WATER QUALITY MEMORANDUM Utah Coal Regulatory Program

TO: Internal File
THRU: James D. Smith, Permit Supervisor *JS 4/19/10*
FROM: Steve Christensen, Environmental Scientist *SKC*
RE: 2009 3rd Quarter Water Monitoring, Canyon Fuel Company (CFC), LLC, Dugout Mine, C/007/0039-WQ09-3, Task ID #3379

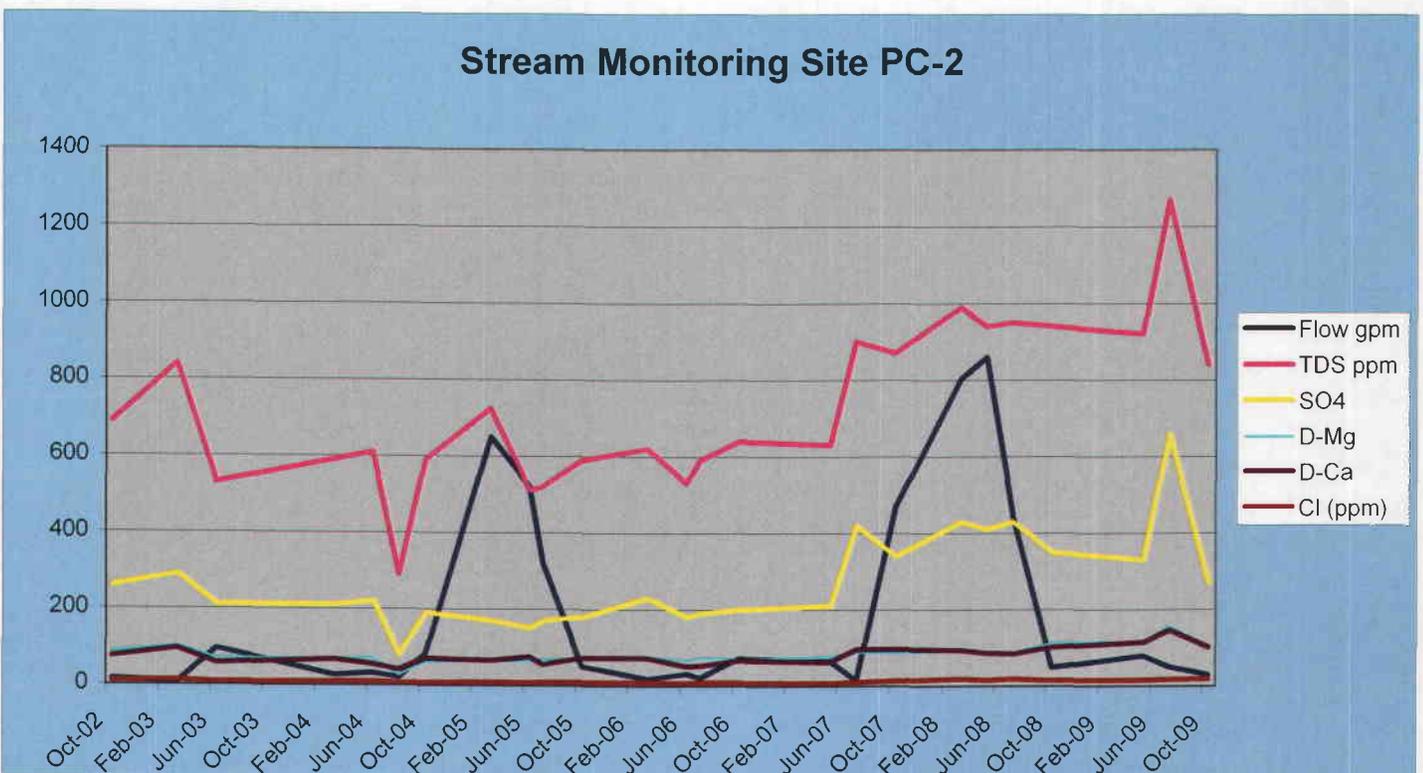
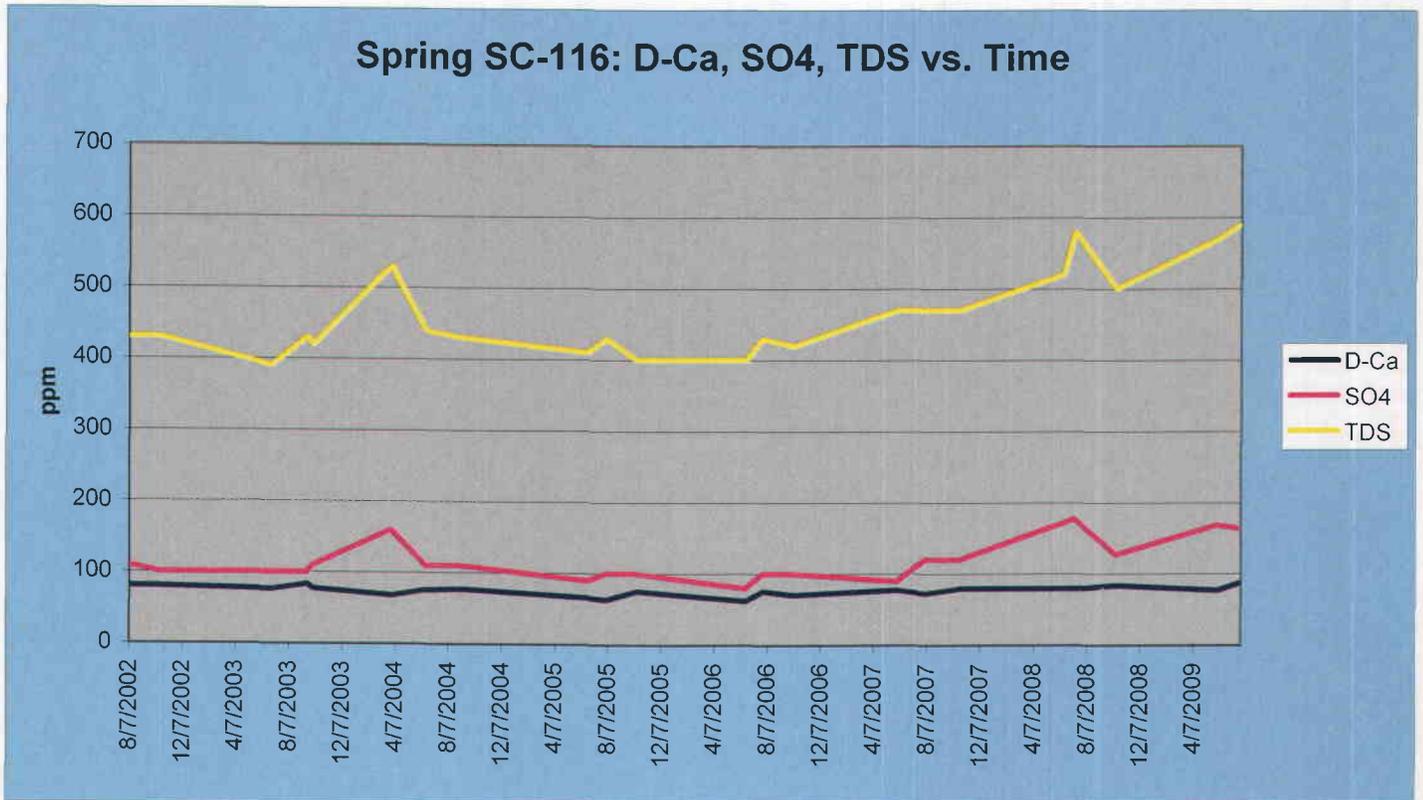
- **SC-116** reported elevated concentrations of SO₄, TDS and T-Cats the previous quarter. For the second consecutive quarter, SO₄, TDS and T-Cats were reported outside of two standard deviations. Additionally, D-Ca, was reported outside of two standard deviations. (See Chart Below).
- **SC-65** had reported elevated concentrations of D-Ca, T-Alk and bicarbonate (Bcarb) the previous quarter. For this quarter, the reported concentrations of all required parameters were within two standard deviations of the mean.

DC-1 reported D-Na concentrations within two standard deviations of the data set. Historically, this site has produced erratic D-Na trends typified by spikes in the late spring/early summer. (See Chart Below)

Stream Monitoring Site PC-2

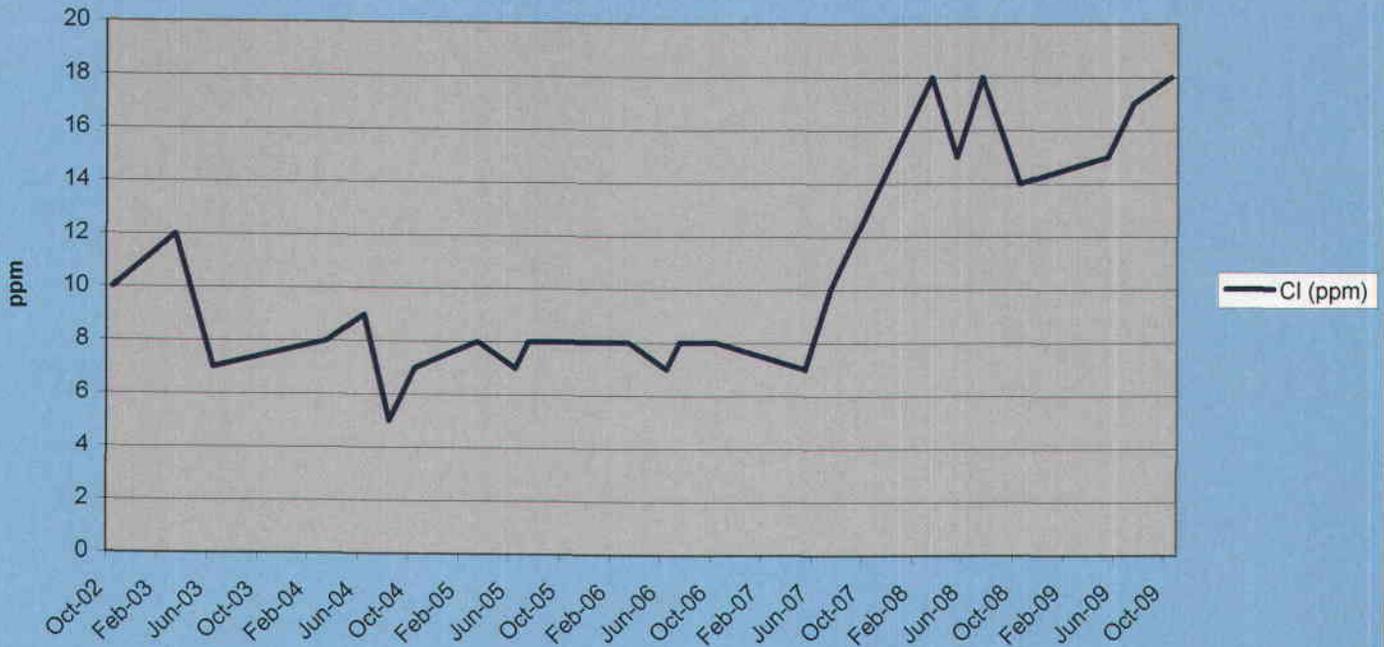
During the previous quarter, site PC-2 had reported several parameters outside of two standard deviations (D-Ca, D-Mg, total alkalinity and bicarbonate). In addition to the aforementioned parameters being outside of two standard deviations for the second consecutive quarter; field conductivity, chloride, total cations, total anions, sulfate and total dissolved solids were also outside of two standard deviations. (See Chart Below).

Monitoring Wells DH-1, DH-2 and DH-3: Water Level vs. Time

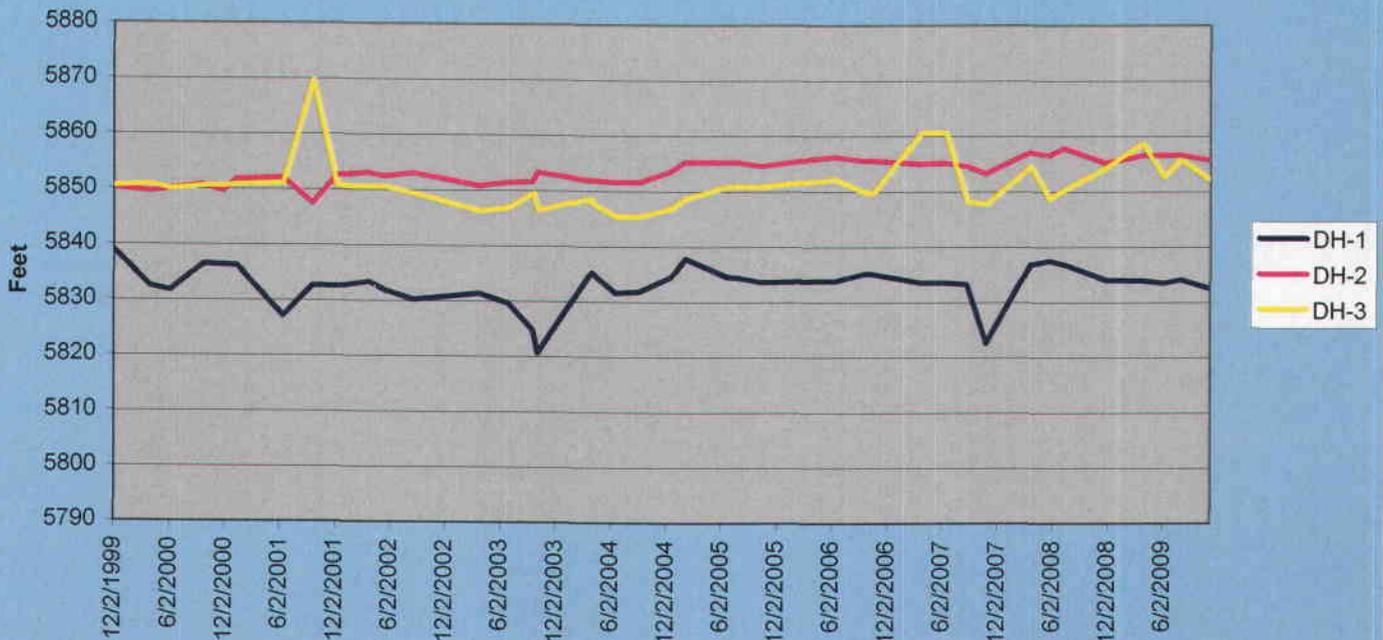
Water levels reported for wells DH-1, DH-2 and DH-3 were all within two standard deviations of the mean. (See Chart Below).

Monitoring Well GW-10-2

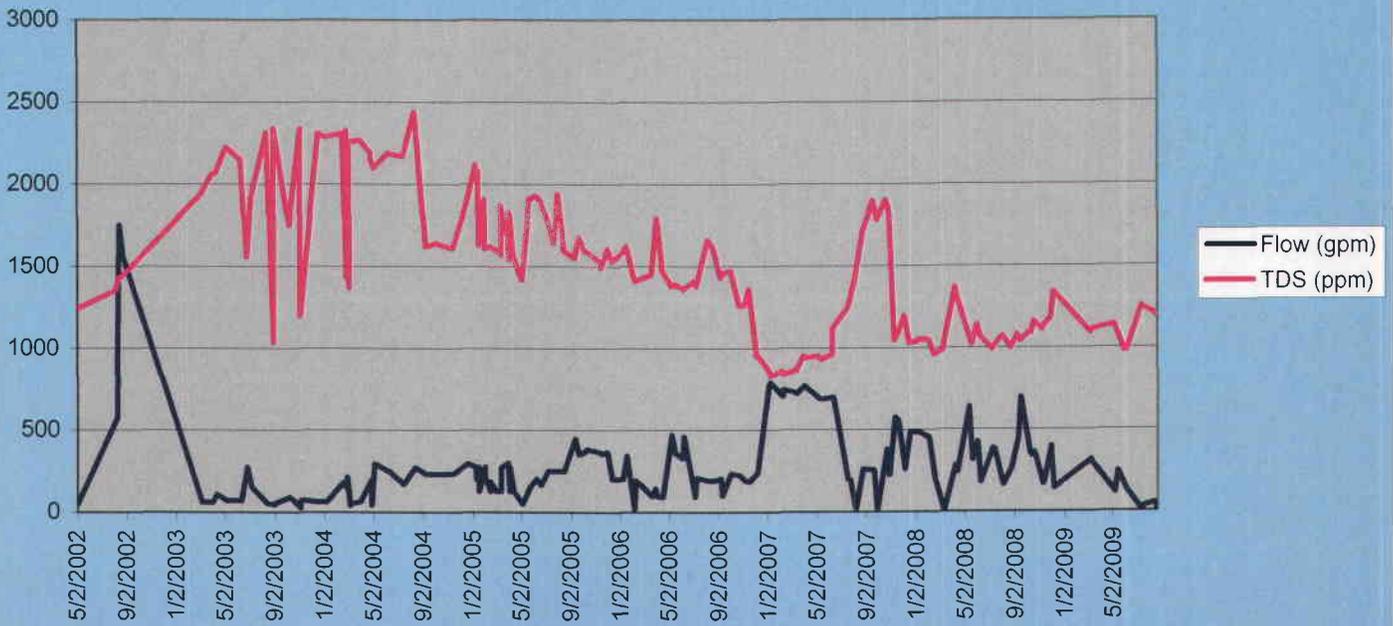
For the second time in the last three quarters, monitoring well GW-10-2 reported a depth to water outside of two standard deviations from the mean (reported value-757.08 ft., average value-738.79 ft.). Continued monitoring of water levels in well GW-10-2 will be conducted to ascertain if a downward trend is emerging. (See Chart Below).
